**From:** David Harrold  
**Sent:** 08 January 2018 11:18  
**To:** Rebecca Biggs  
**Subject:** RE: DC/17/04483 and DC/17/04484

<b>1</b>	<b>Application Number</b>	DC/17/04483 DC/17/04484 Bell Hill Cottage, The Street, Rickinghall	
<b>2</b>	<b>Date of Response</b>	03/11/2017	
<b>3</b>	<b>Responding Officer</b>	Name:	Rebecca Styles
		Job Title:	Heritage Officer
		Responding on behalf of...	Heritage
<b>4</b>	<b>Summary and Recommendation</b> (please delete those N/A)  Note: This section must be completed before the response is sent. The recommendation should be based on the information submitted with the application.	<p>1. The Heritage Team considers that the documentation submitted in support of this application falls below the requirements of paragraph 128 of the NPPF, as no assessment of the impact of the proposed work on the listed building has been made. The Heritage team is not opposed to the change of use, however does have concerns regarding the necessity and justification of the proposed internal works through introduction of fire lining/suspended ceiling and the possible effect on the internal character of the Grade II listed Bell Hill Cottage.</p>

## **The Newsagent, Bel

**Diagram 2 Flue or Chimney Outlet Highlighting Unsafe Shaded Area**

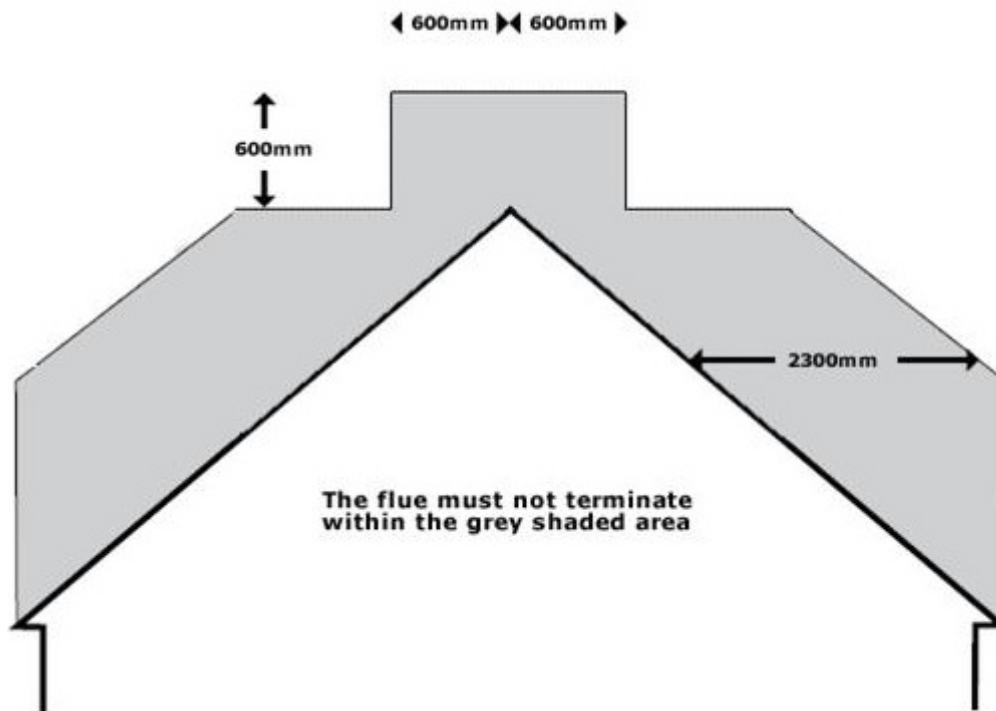
Re points 20 – 25 of the letter, it is correct that to aid dispersion of residual odour (after filtration) it is recommended that this is at or above ridge height but this is not critical or the only factor I have taken into account. As the predominant wind direction will take residual odour away from Bell Hill House and there are no windows in the roof (as far as I am aware) this should be satisfactory providing the usual grease and carbon filters are incorporated into the design. There is no definitive methodology to calculate this type of flue height for kitchen ventilation, only unofficial guidance/good practice.

I've attached a diagram below which shows the relationship of ridge height for chimneys and flues in the Building Regulations. The further away from the ridge you go the lower the discharge height can be.

As per my response, I do not object providing filtration and silencing equipment is installed. This could be made a condition on any approval given.
